Subject: AP1000 COL Response to Request for Additional Information (TR 29)

Westinghouse is submitting a revised response to the NRC request for additional information (RAI) on AP1000 Standard Combined License Technical Report (TR) 29, APP-GW-GLR-044, Nuclear Island Basemat and Foundation. This RAI response is submitted in support of the AP1000 Design Certification Amendment Application (Docket No. 52-006). The information included in the response is generic and is expected to apply to all COL applications referencing the AP1000 Design Certification and the AP1000 Design Certification Amendment Application.

RAI Response Number: RAI-TR29-SRSB-01
Revision: 1

Figure 6-37
2-Inch Cold Leg Break, RCS Pressure

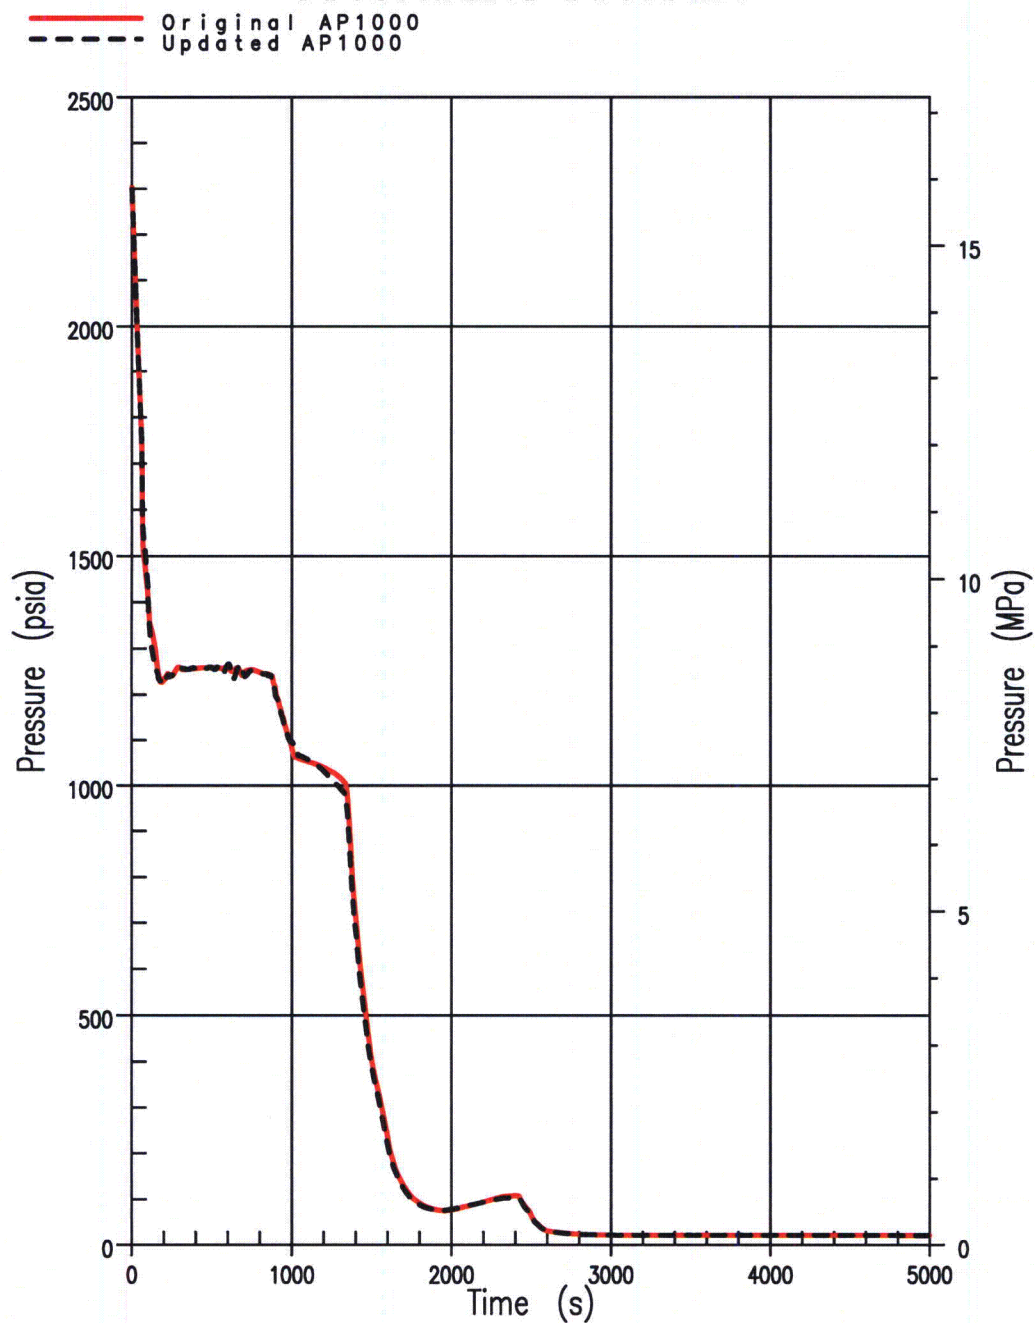
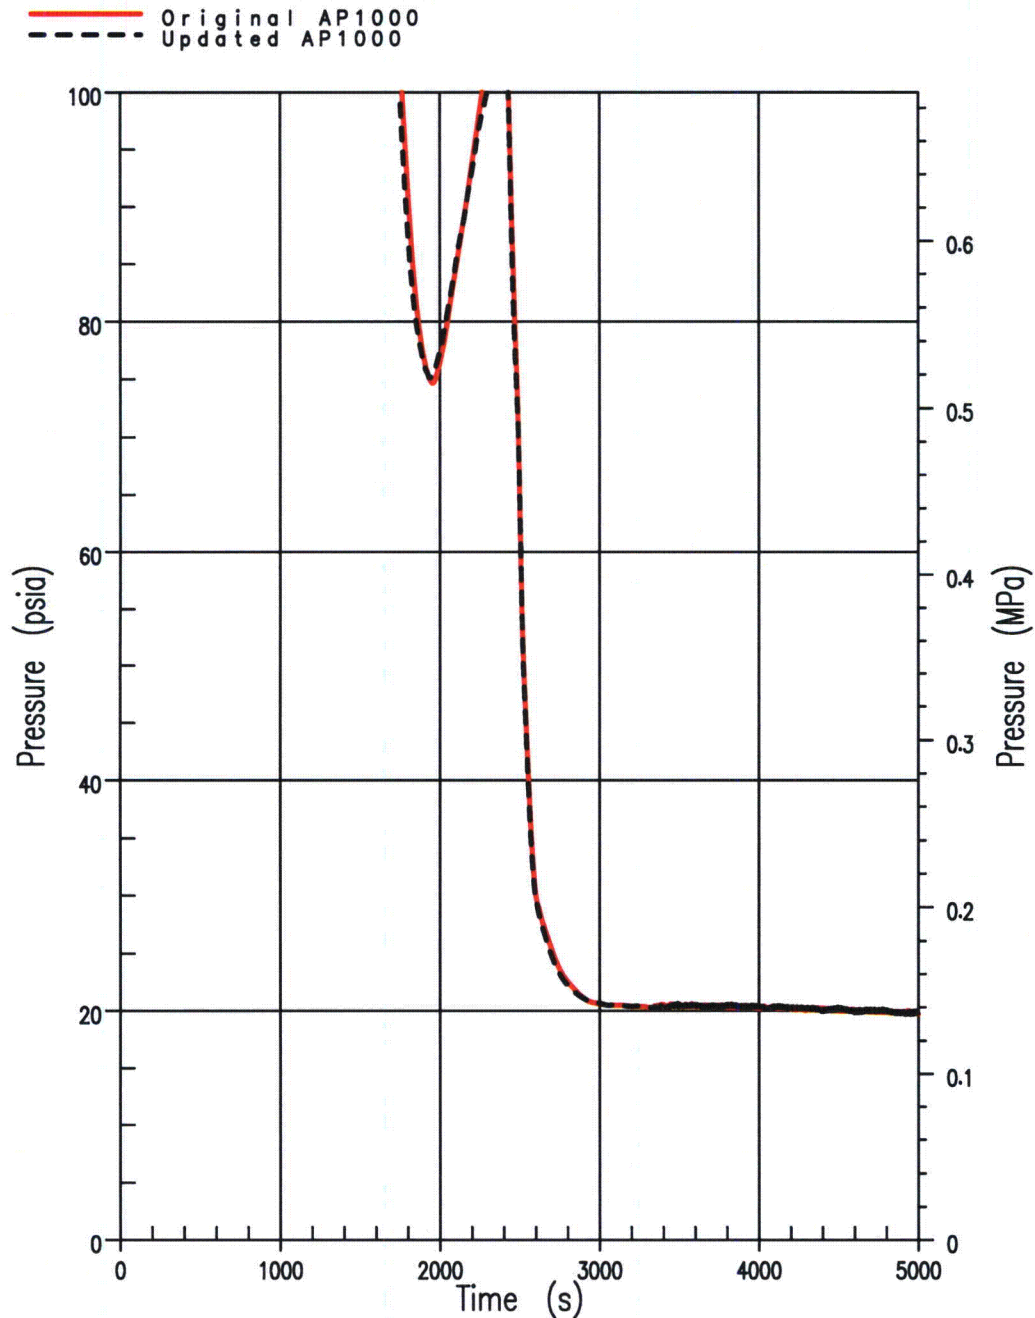
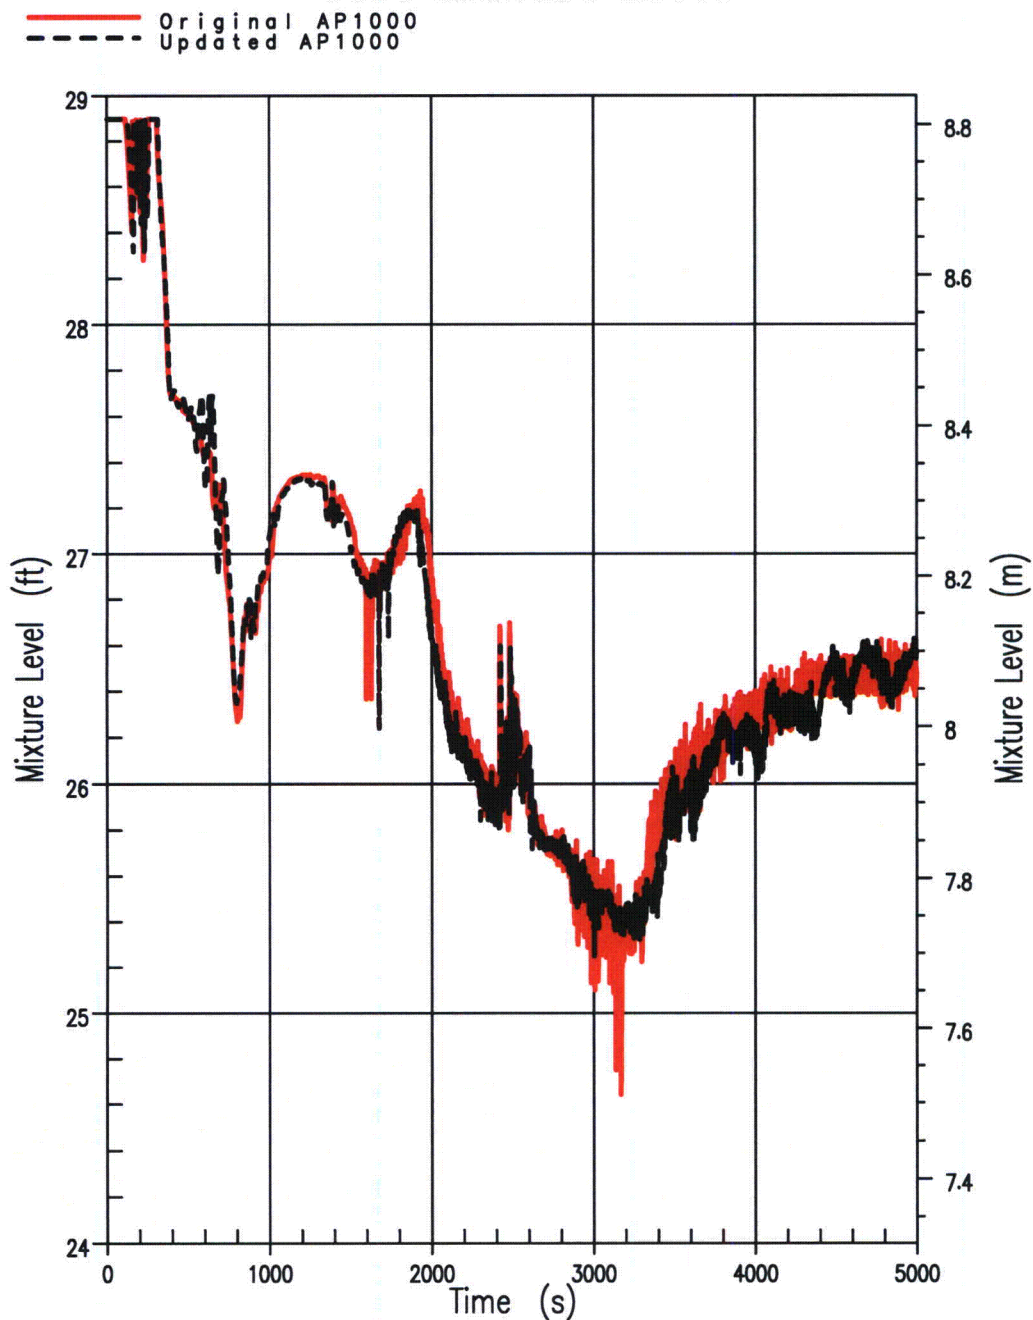
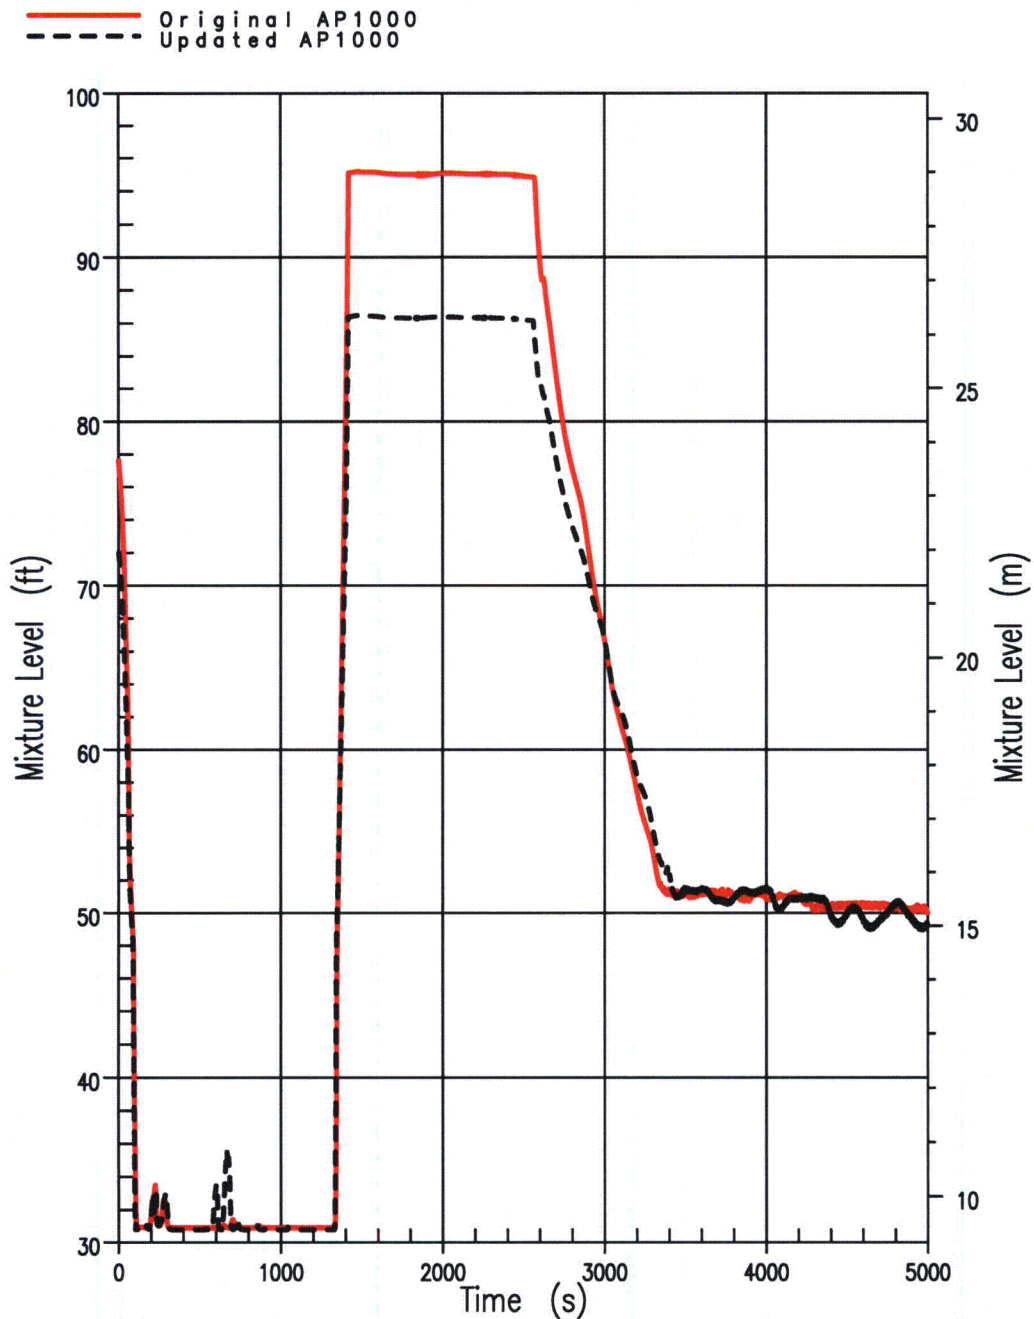
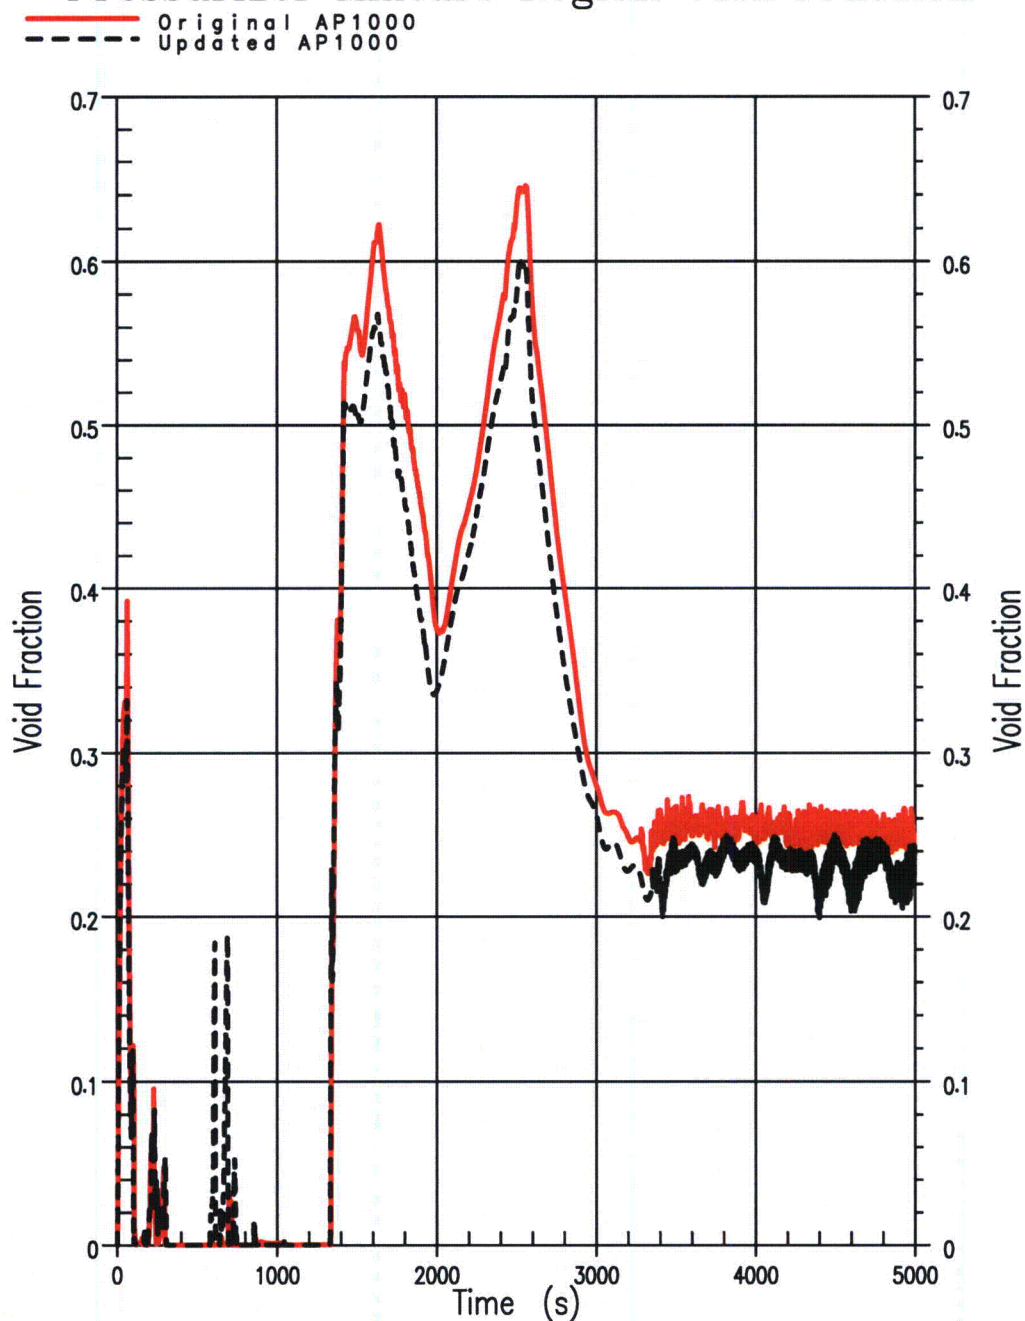
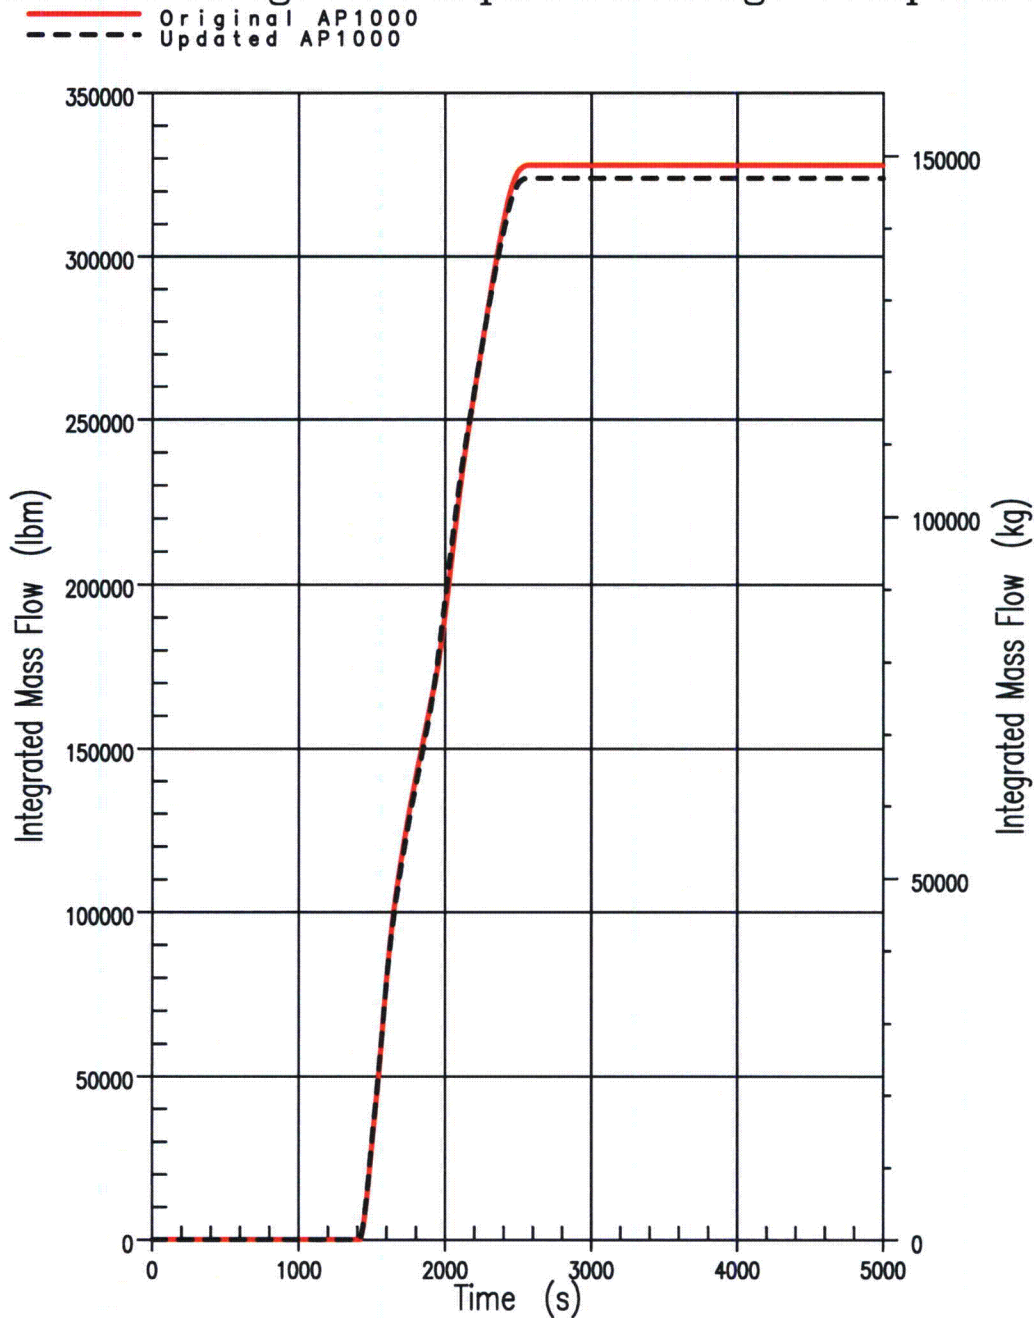
Please provide an evaluation of the impacts of these proposed changes on the analysis results of each of the transients and accidents in DCD Chapter 15. The evaluation should demonstrate either the analysis results of DCD Chapter 15, Revision 15, remain bounding and valid, or the effects of these changes are insignificantly small that the applicable acceptance criteria for these transients and accidents remain complied with.

Table 6-3 and Figures 6-37 through 6-46 present a comparison of the 2-Inch Cold Leg break simulations. The results again demonstrate the effect of the change in the reactor internals design (including the revised Pressurizer). Decreases in both the Pressurizer Mixture Level (Figure 6-40) and Pressurizer Void Fraction (Figure 6-41) were observed as a result of the Pressurizer change. For the 2-Inch Cold Leg Break, this subsequently reduces both the Automatic Depressurization System (ADS) Stage 1-3 liquid discharge (Figure 6-42) and ADS 1-3 vapor discharge (Figure 6-43). The overall effect of these design changes is slight variations in the Reactor Coolant System (RCS) inventory over the transient simulation period (Figure 6-46) with about the same predicted minimum RCS inventory. No significant changes in the RCS Pressure (Figures 6-37 and 6-38), Core Mixture Level (Figure 6-39), and DVI injection characteristics (Figures 6-44 and 6-45) are observed as a result of the design change implementation.
